Diavik Diamond Mines (2012) Inc.
P.O. Box 2498
Suite 300, 5201-50th Avenue
Yellowknife, NT X1A 2P8
Canada
T (867) 669 6500
F 1-866-313-2754

Subject: DDMI Request for WRSA-NCRP Cover Modification

Diavik Diamond Mines Inc. REQUEST FOR INFORMATION

RFI NUMBER:	DDMI-4110-005
	Date Created:	9/October/2019

Figure 1 - NCRP Regions

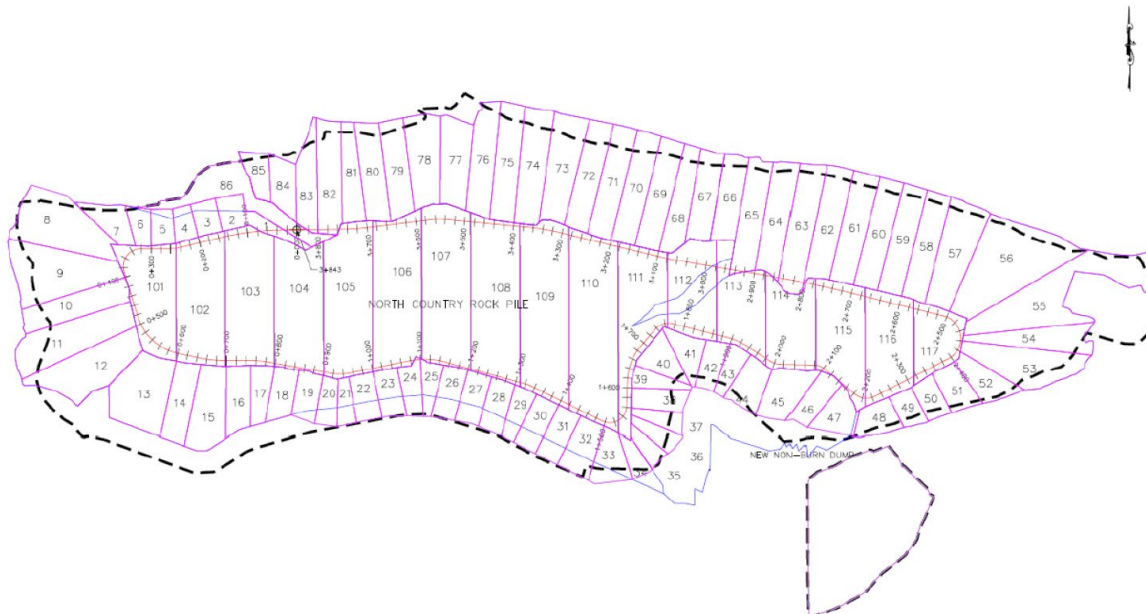
The A21 pit is the current source of the till material. The till from the deepest location of the former lake contains till and lakebed sediments (LBS) with a higher percentage of fines. The fine-grained lakebed sediments with higher moisture content have been placed on the top of the NCRP to reduce stability concerns with placing the material on the 3H:1V slope. The material has been end-dumped in the horizontal regions 101 to 117 (Figure 1). Due to the end dump placement methodology and high moisture content, the material has settled out to an average thickness of 0.8m to 1.6m.

Figure 4. Gradation Curve for the sample collected from the top region 101 to 117. The red dash line is the specification range of percent passing the 0.425mm sieve.

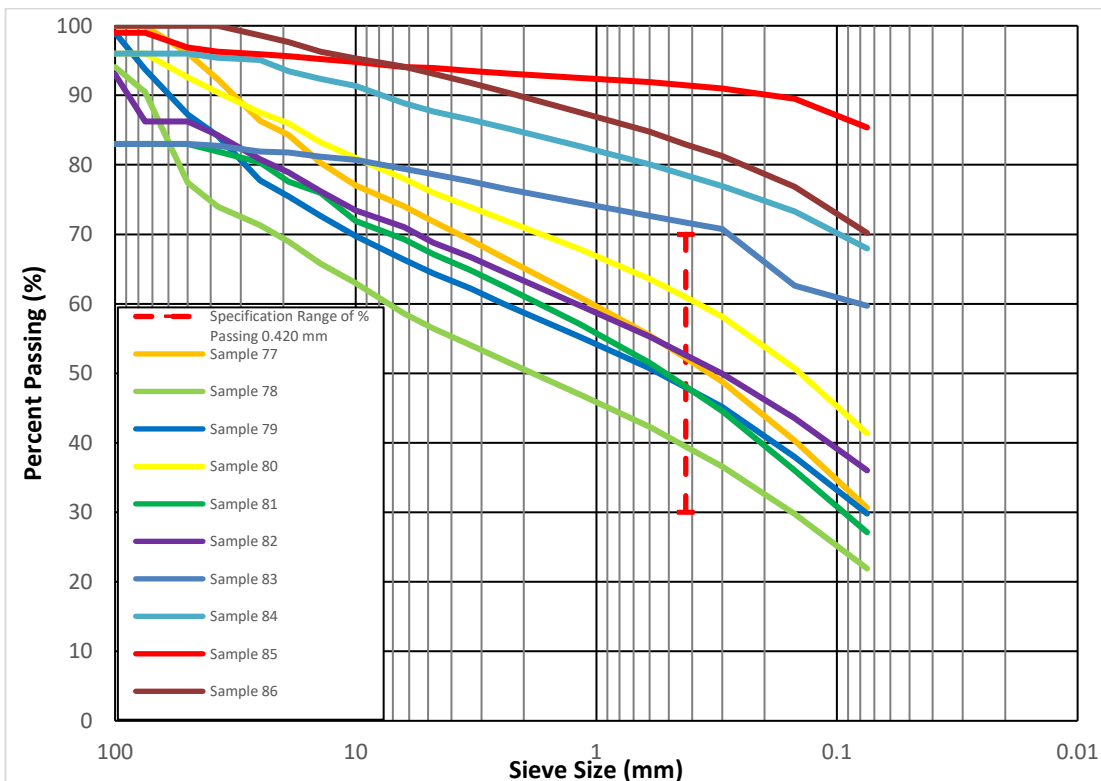
For the till layer to retain moisture, a content of 30 to 70% passing the 0.425 mm sieve is required. The till placed to date has between 40% and 90% passing the 0.425 mm sieve. A summary of grain size distribution plots for each tested sample is presented in Figure 4. The relationship between grain size and moisture content is shown in Figure 5 which indicates higher moisture content with higher percent passing the 0.425mm sieve.

Figure 5. Gradation results. Gravimetric water content versus percent passing 0.425mm sieve.

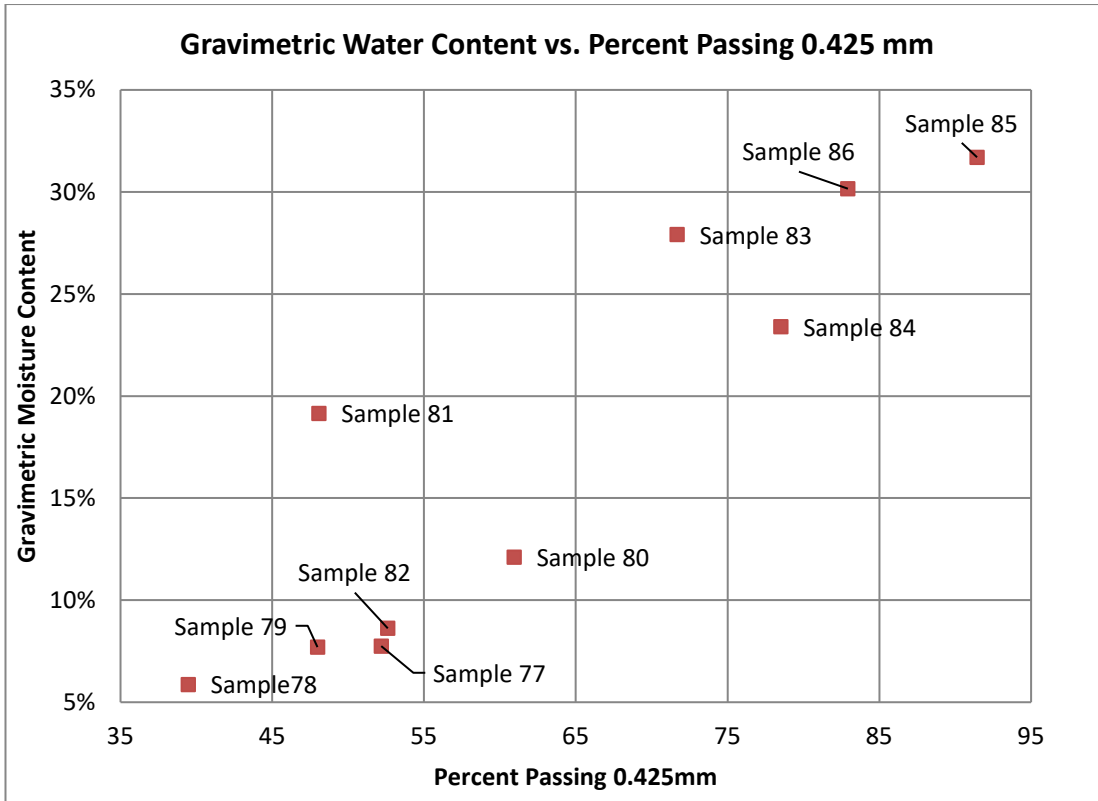
The material in regions 101 to 105 contains a significant amount of fines, resulting in an average gravimetric moisture content of 23%GWC. The thermal analysis supports the till thickness reduction to 1.0m as this is significantly greater than the 10% minimum and the 15% used in the thickness scenarios (Figure 3).

Figure 1: North Country Rock Pile Construction Region Plan

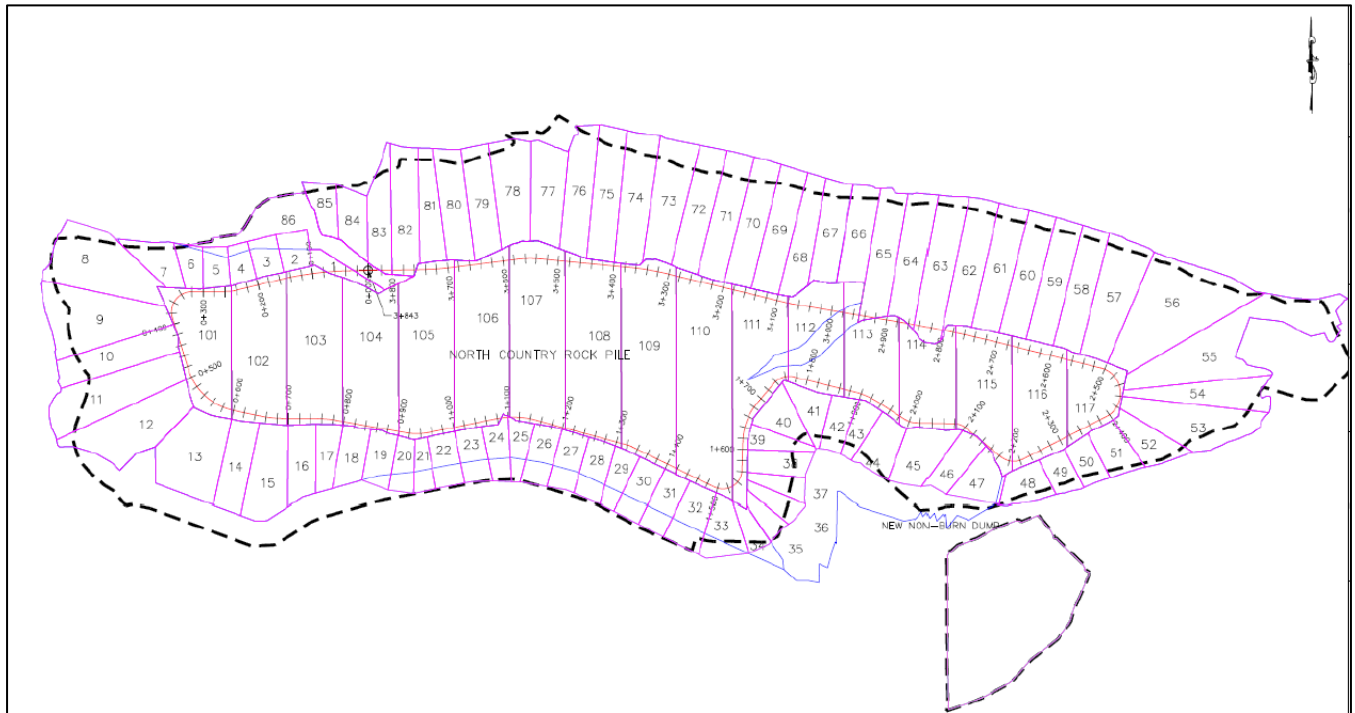
DDMI request confirmation that the proposed reduction in material thickness on the top face of the NCRP will not affect the stability of the cover system.

Based on DDMI's internal memo titled Proposed North Country Rock Pile Crest Till Thickness Design Modification (3 October 2019), Golder understands DDMI has proposed to reduce the thickness of the till layer for the closure cover system from 1.5 m to 1 m on the top surface of the North Country Rock Pile (NCRP). Golder understands that this proposed change will be for the top surface of the NCRP only (Regions 101 to 117 shown in Figure 1), and the thickness of the till layer of the cover to be placed over the side slopes of the NCRP, including areas re-sloped to 3H:1V, will remain unchanged at 1.5 m thickness measured perpendicular to the slope.

To confirm the proposed change in till thickness will not adversely impact the stability of the top of the NCRP, the stability of the reduced to 1 m till thickness in the cover system was assessed and compared to the NCRP design with 1.5 m till thickness in the cover system.

The results indicate that a reduction in till thickness to 1 m will not reduce the stability of the cover. For the long term condition, the Factor of Safety against solifluction, skinflows, and bimodal flows increases slightly, indicating an increase in stability.

Based on the results presented above, Golder can confirm that a reduction in till thickness on the top surface of the NCRP will not affect the overall stability of the cover system.
